**ADDENDUM NO. 01 – PORTAGE PUBLIC SCHOOLS – HAVERHILL ELEMENTARY SCHOOL BP 6:
CONSTRUCTION**

ADDENDUM NO. 1 (BP 6)

DATE OF ISSUANCE:	July 26, 2023
PROJECT:	Haverhill Elementary School Bid Package 6: Construction 6633 Haverhill Avenue Portage, MI 49024
OWNER:	Portage Public Schools
ARCHITECT'S PROJECT NO.:	21-237.20
ORIGINAL BID ISSUE DATE:	June 30, 2023

1 SECOND FLOOR FRAMING PLAN
 3/32" = 1'-0"

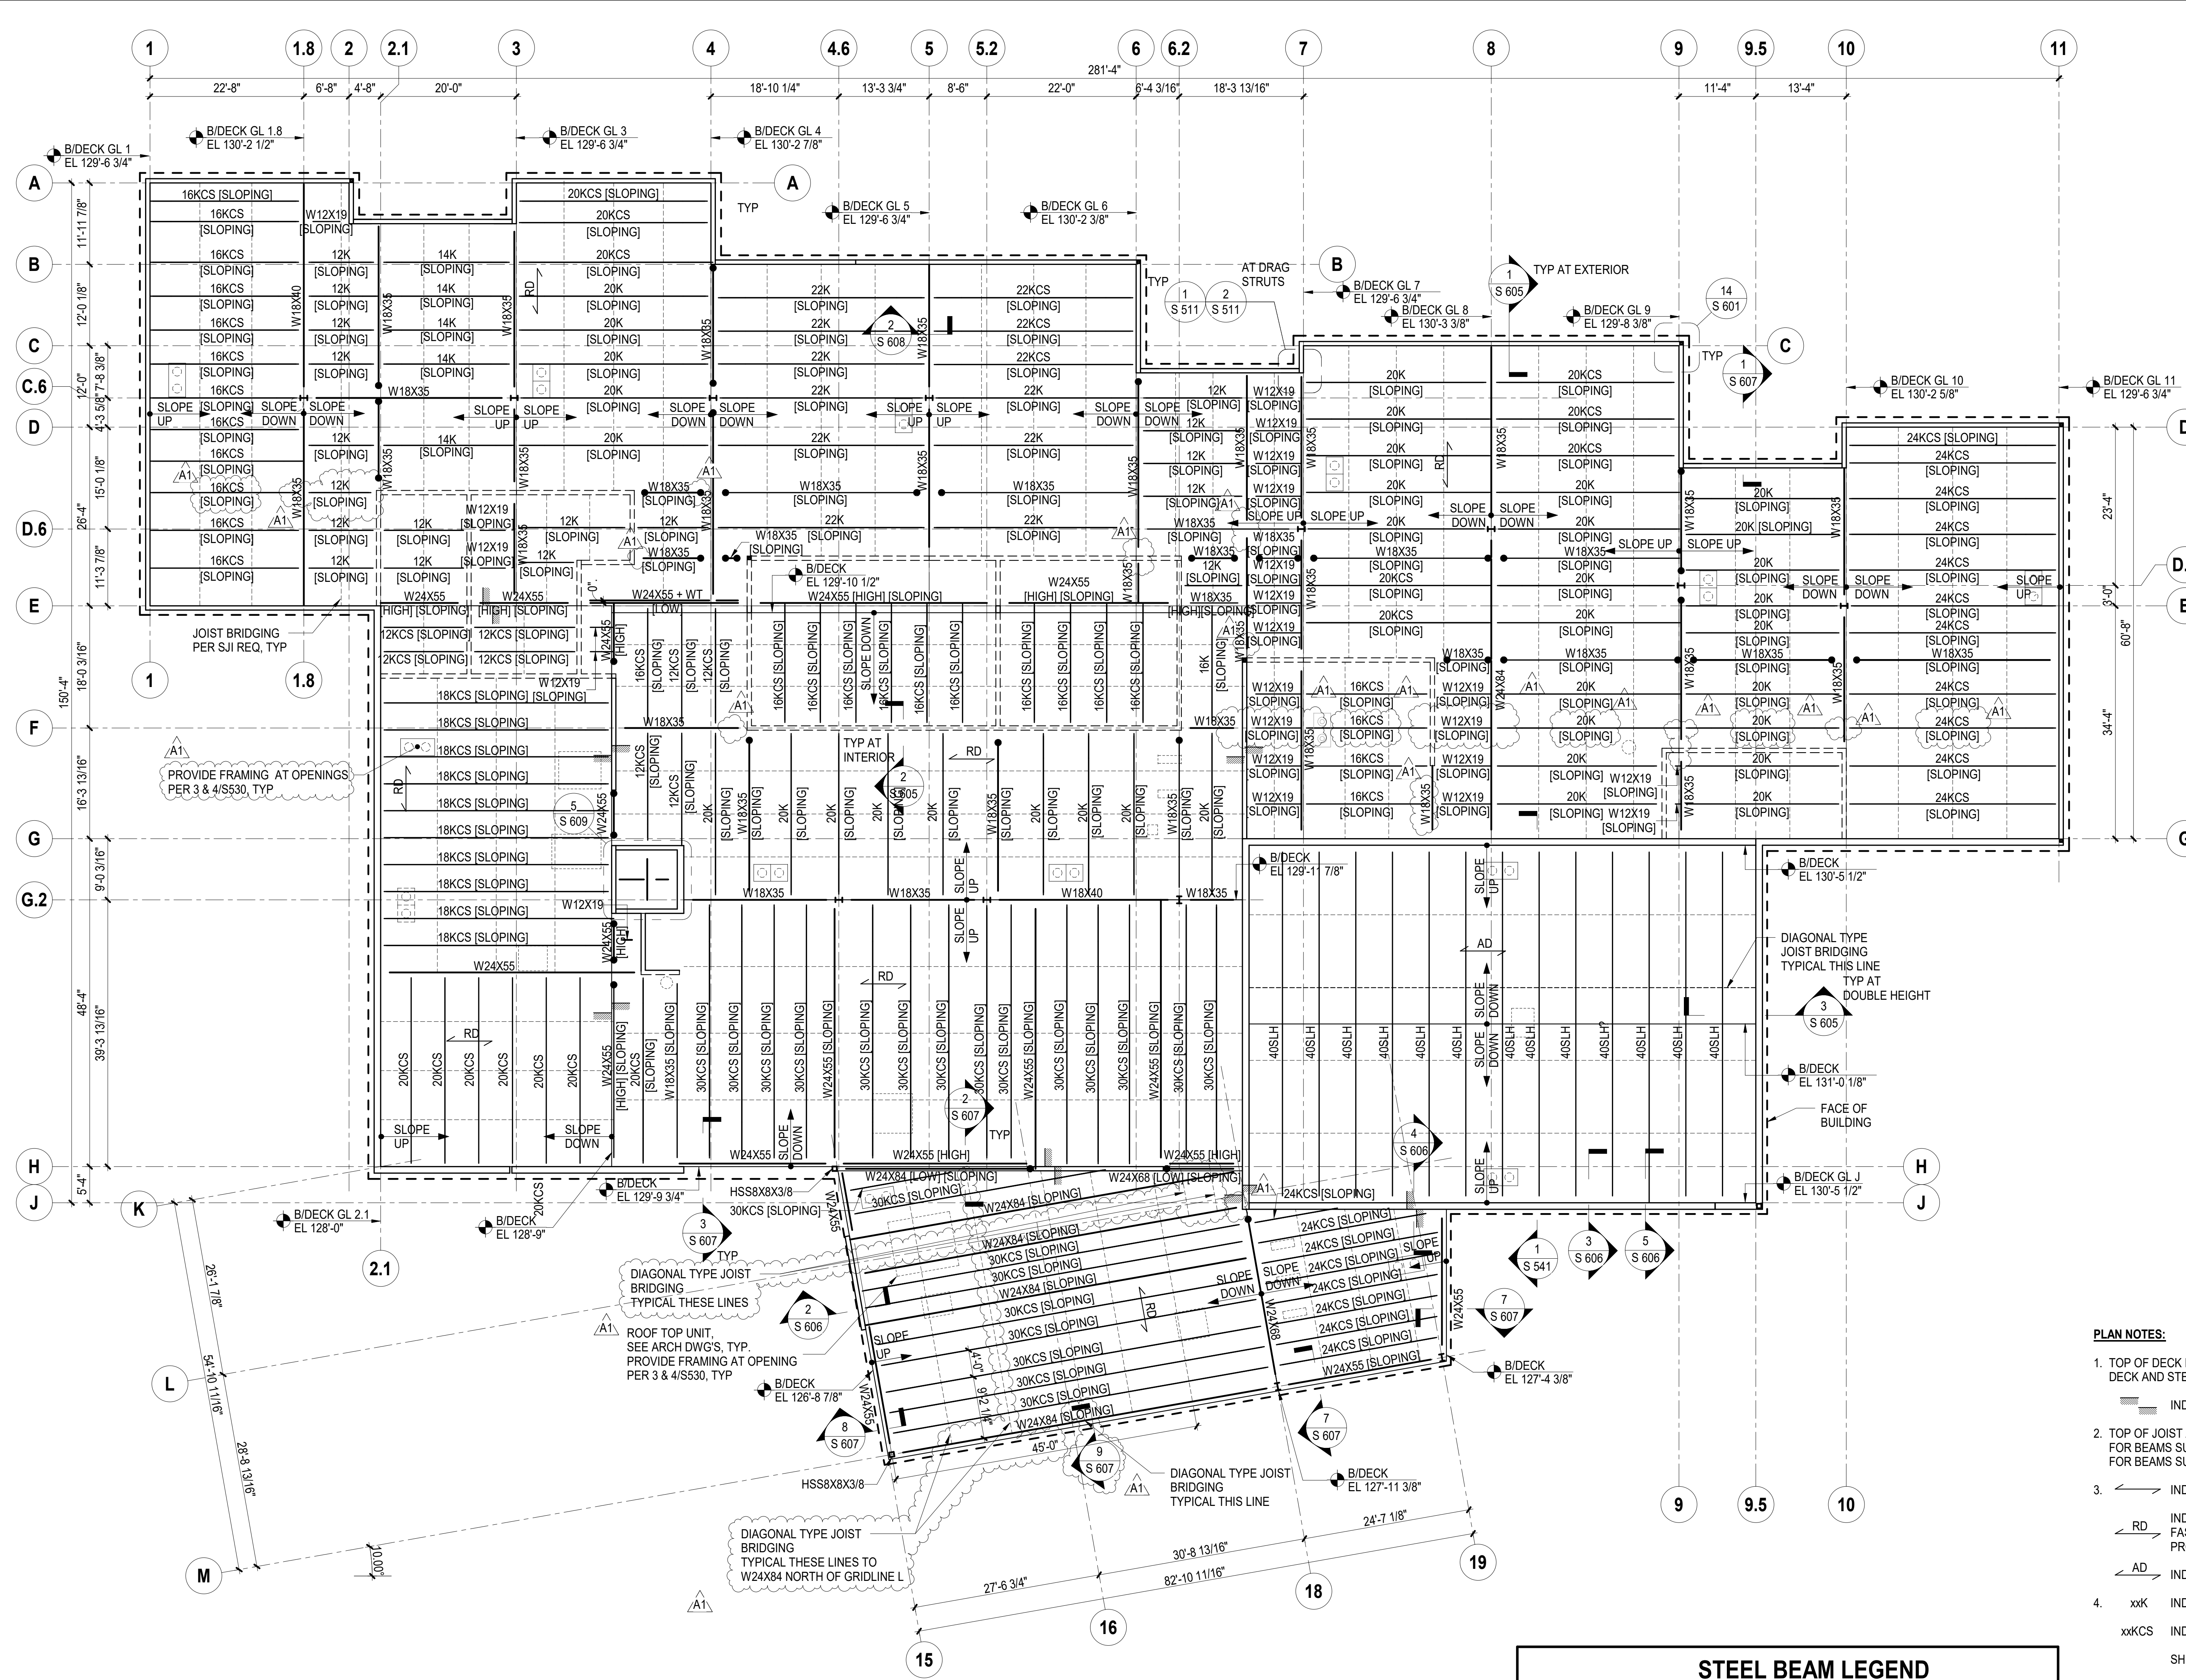
Added additional rows of diagonal joist type bracing to account for eccentric loading on wide flange beams

Eliminated horizontal bracing at low roof and replaced with special roof attachment zone and revised beam size

Revised canopy framing

SHEET NUMBER
 S 112
 21-237.25

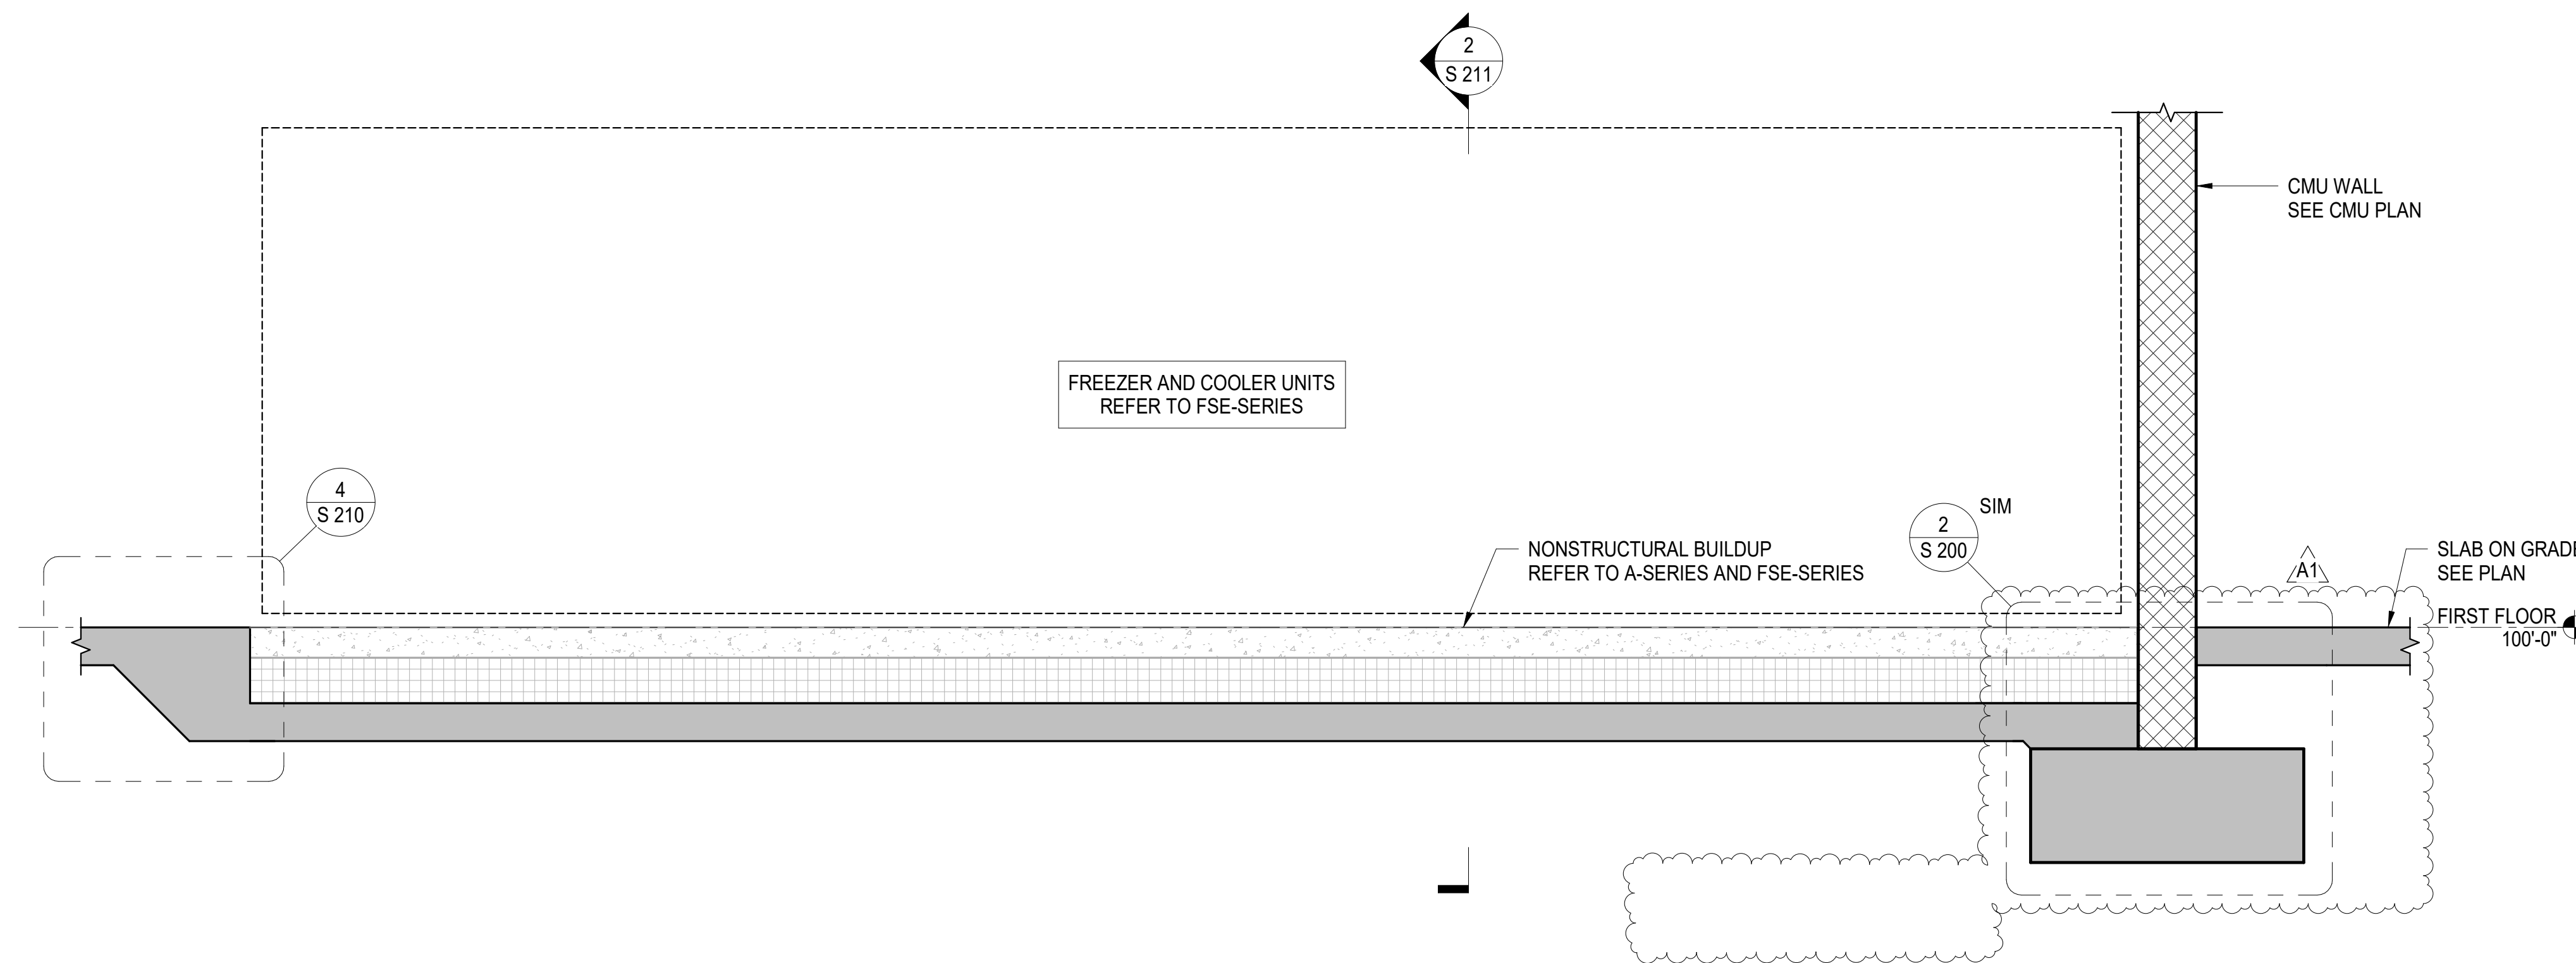
Revised pier requirement beneath posts bearing on CMU walls

Revised various lintel lengths and sizes as required per revised details in S500 and S600 series

Revised post size as required per revised details in S500 and S600 series
